UNITED STATES OF AMERICA
NUCLEAR REGULATORY COMMISSION

In the Matter of)
)
UNION ELECTRIC COMPANY)
)
(Callaway Plant, Unit 1))

Docket No. STN 50-483 OL

APPLICANT'S ANSWERS TO INTERROGATORIES
OF JOINT INTERVENORS (FIRST SET)

EP112 & EP112A

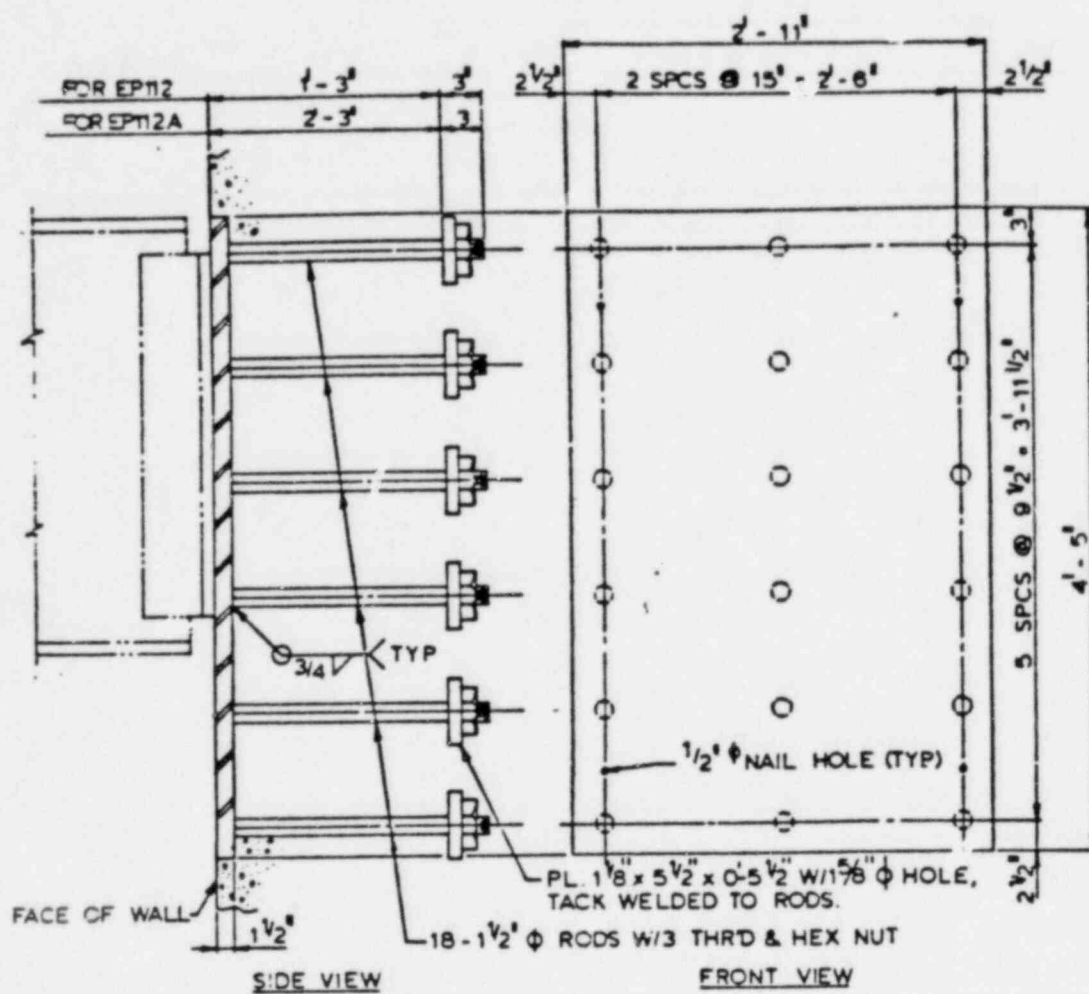
(i) Of the subject embedded plates, only the plates identified with plate mark numbers EP112, EP112A, EP212, EP312 and EP412 have manually welded rod anchors without threads. These rod anchors, which are not threaded, were oversize in design to account for the possibility of threading. For details of these plates see Figure 5(b).
